Meeting: 10/21/2020
Project: Glencoe Building
Applicant: Design Innovation Architects

Level I Minor Alteration of an Existing Building/Structure
Repair and rehabilitation of three-story porch on the Glencoe Building.

10-E-20-DT

Repair and Maintenance of Entry-Porch and Balconies at the

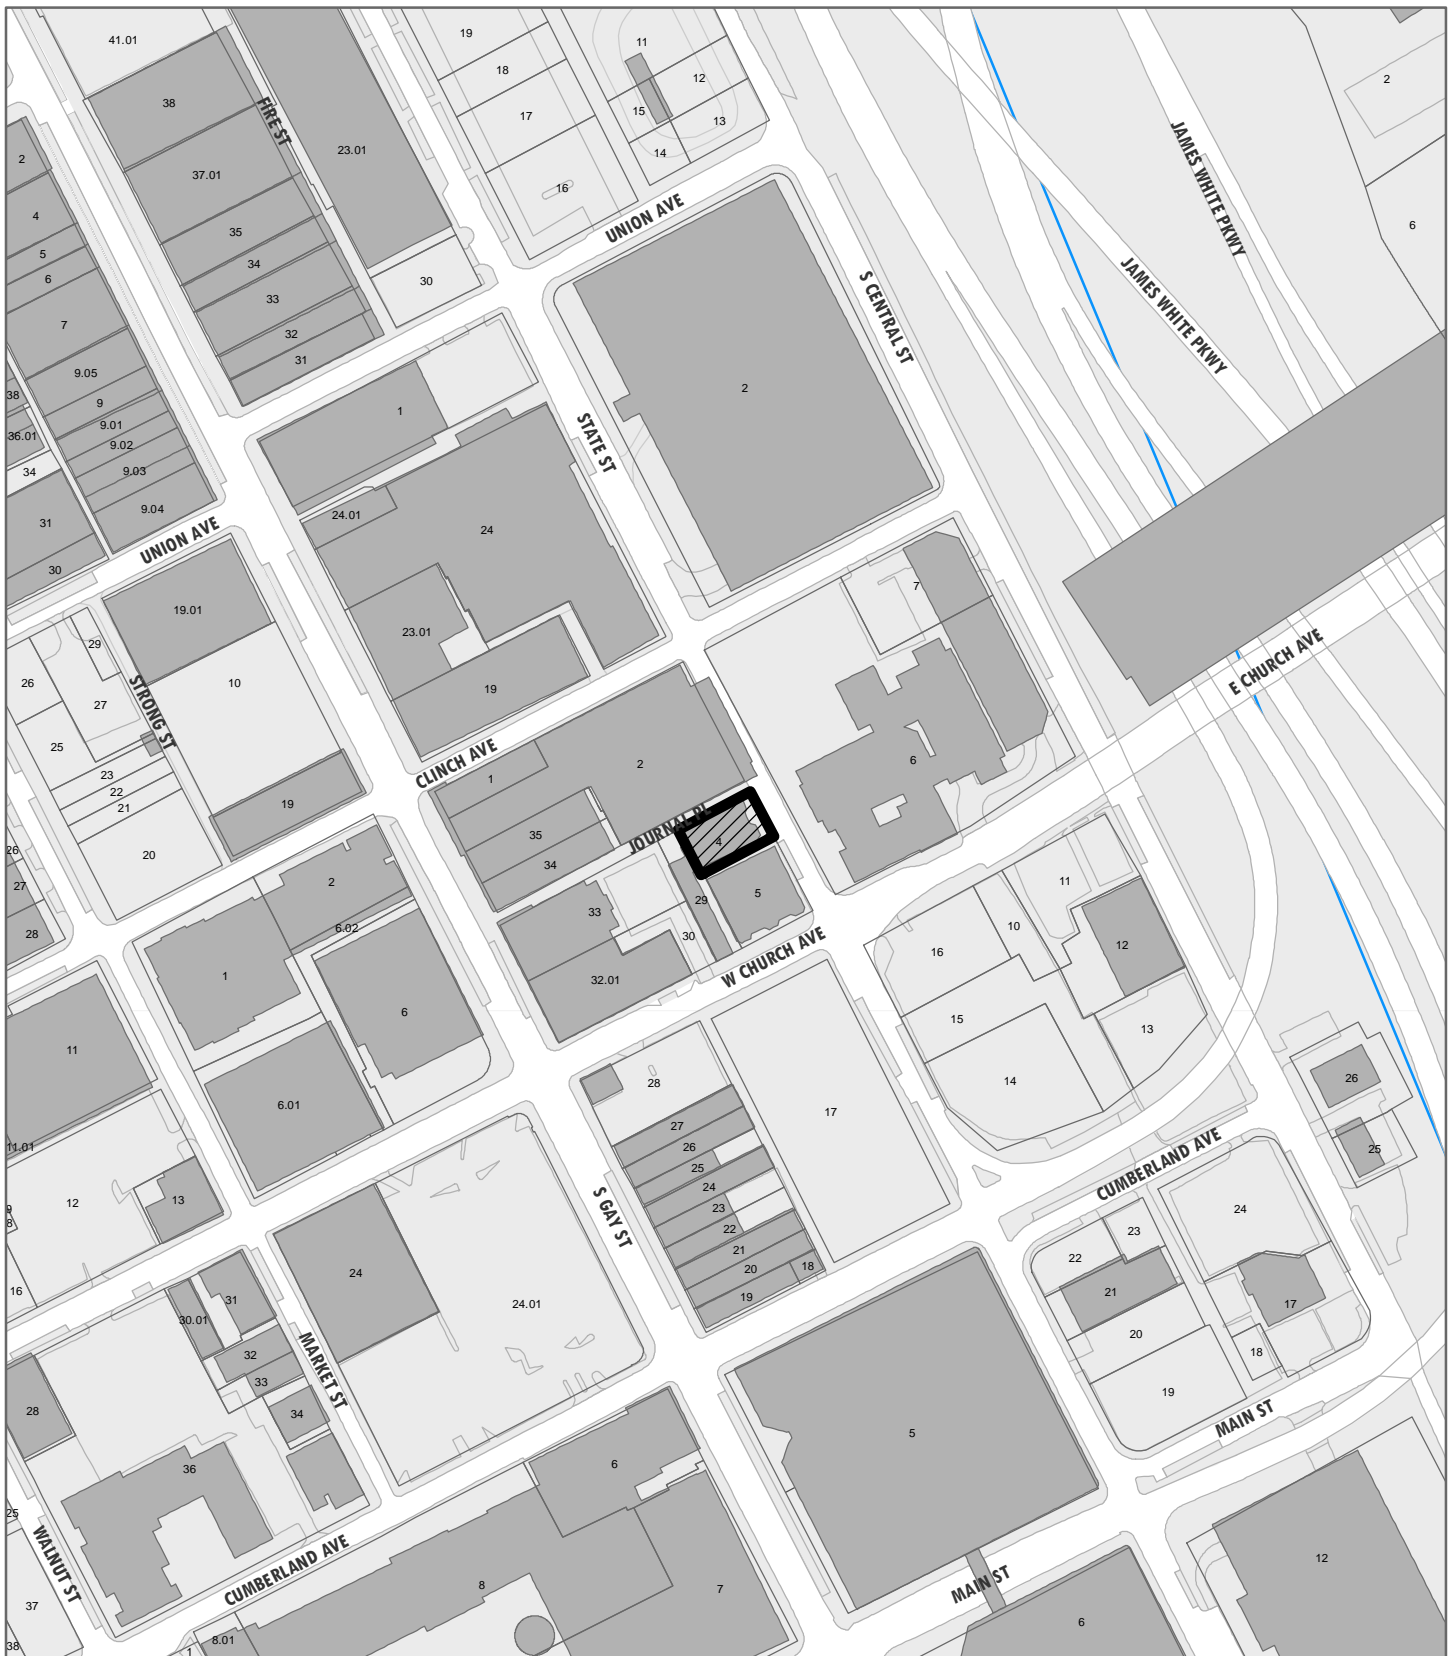
The Glencoe Building is a contributing structure to the Gay Street National Register Historic District, so the Historic Resources section of the design guidelines applies. Reconstruction of the porch foundation walls, including salvaging and reinstalling the original brick on the foundation's exterior, meets the design guidelines and will ensure the three-story porch's longevity into the future. New mortar joints will match existing conditions.

Remediation of the porch decking's current condition is necessary. The previous porch decking was a wood tongue-and-groove material, measuring approximately 3" wide, but most of the decking has been removed after deteriorating such that the structural columns damaged sections of the flooring. SOI Standard #6 recommends that "where the severity of deterioration requires replacement of a distinctive features, the new features shall match the old in design, color, texture, and where possible, materials." The proposed replacement material is a capped polymer, composite flooring which is slightly wider (5" wide) than the existing. However, the decking will be installed in a pattern to reflect the existing, with a painted wood trim piece to cover the edges of the flooring. In this application, the use of a more durable replacement material will help avoid future issues with moisture intrusion, the guardrails, and the columns. Recessed and elevated above the street level, the decking is minimally visible from the public right-of-way, and will be visually compatible with the old material in terms of design, color, and texture.

Temporary removal and re-installation of columns, capitals, guardrails, and stone entry steps is appropriate within the guidelines. Guardrails will be re-installed to meet current codes with an additional strip of wood trim added to reduce the distance between the guardrail and the floor decking from 2.5" to 2". If elements (such as columns or capitals) must be replaced, proposed replacement details should be submitted to staff to confirm they reflect the historic materials in size, material, and design.

Staff recommends approval of Certificate 10-E-20-DT as proposed, with the condition that any elements requiring replacement be submitted to staff to confirm they reflect the original elements in size, material, and design.
